ATTACHMENT 4

From: Athreyi@aol.com [mailto:Athreyi@aol.com]
Sent: Sat 10/21/2006 4:34 AM
To: Sabrina Oliver; Gene Poveromo
Subject: Fairway Hill Walking Path

Fairway Hill Subdivision
Site Plan
Chapel Hill, North Carolina

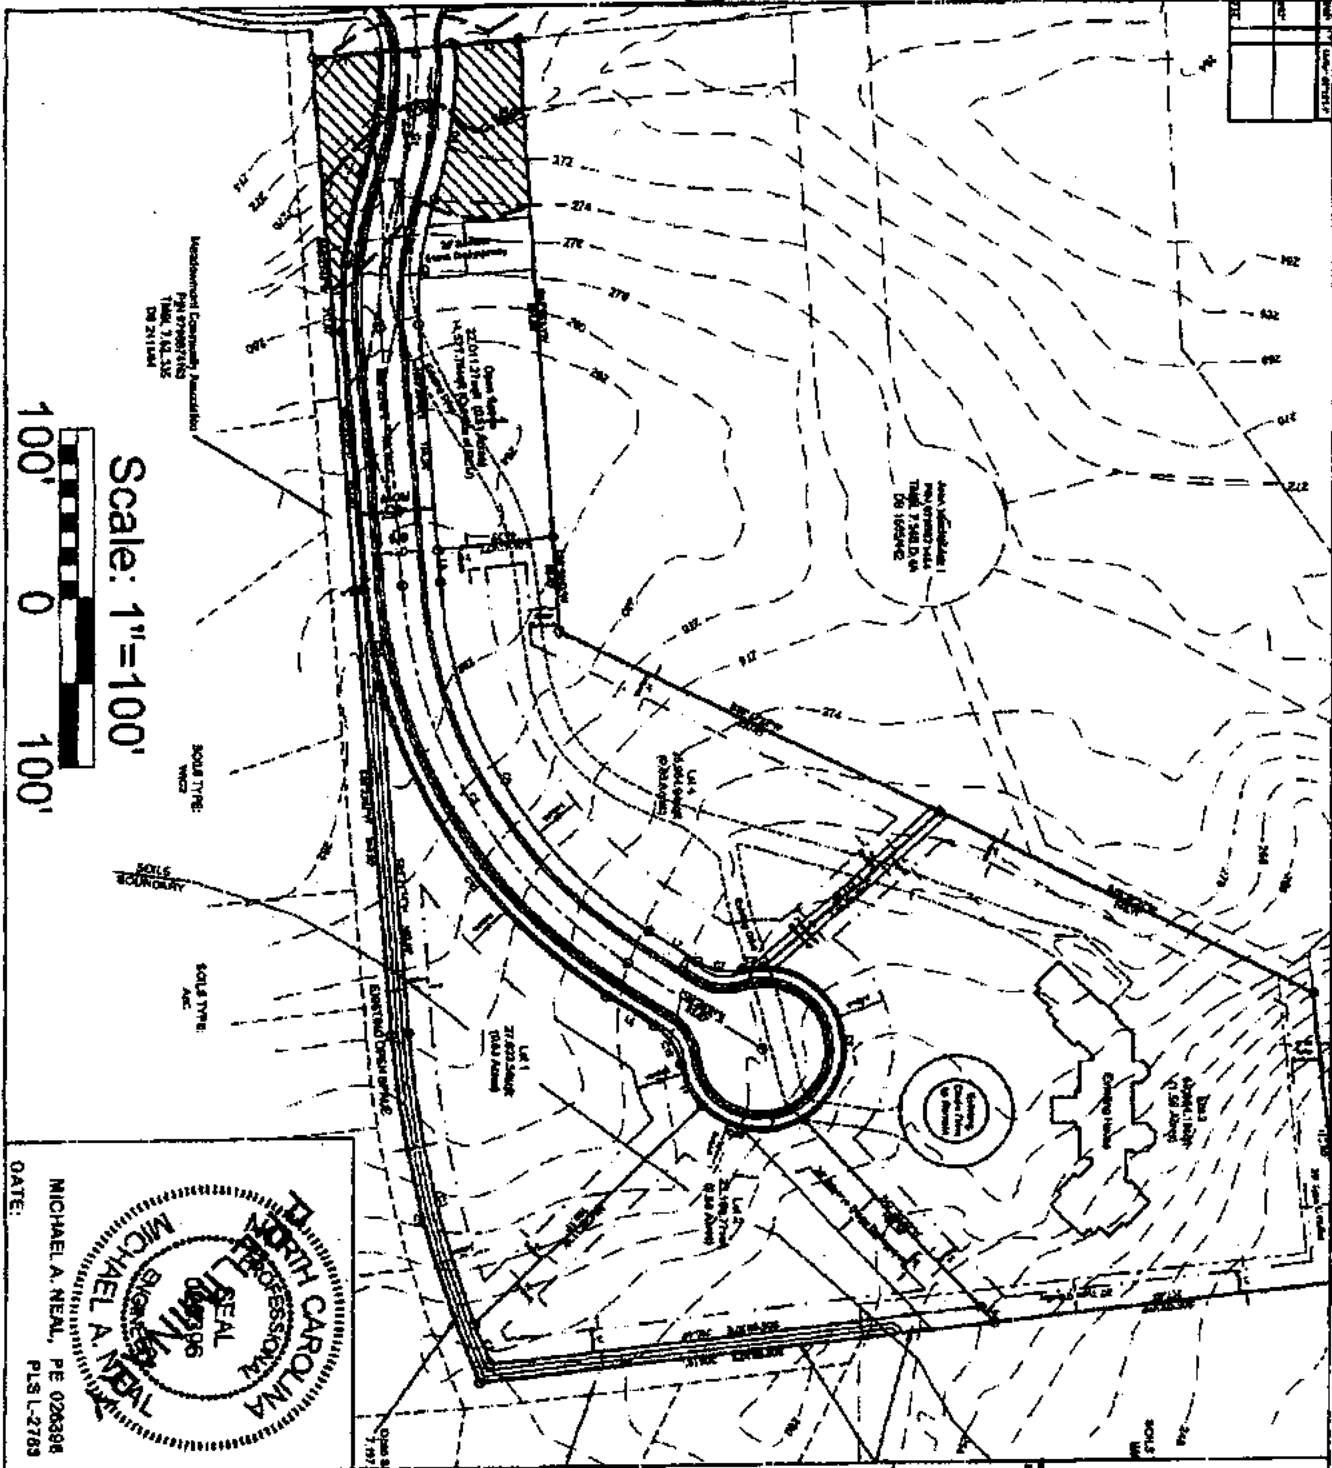
With respect to the proposed site plan, I observe the following:

- a. The cul de sac connects all four proposed lots. Why not locate a pedestrian path of the cul de sac between proposed lots 2 and 3?
- b. The proposed road has been relocated where same would provide the developer with larger and, therefore, more valuable lots at the expense of adjoining property owners. I can only imagine how the Chansky's must feel about the possibility of having public road located a few feet alongside their house. Why not adhere to the earlier proposal which followed the current drive way for some length and did not appear to be a burden to adjoining property owners?
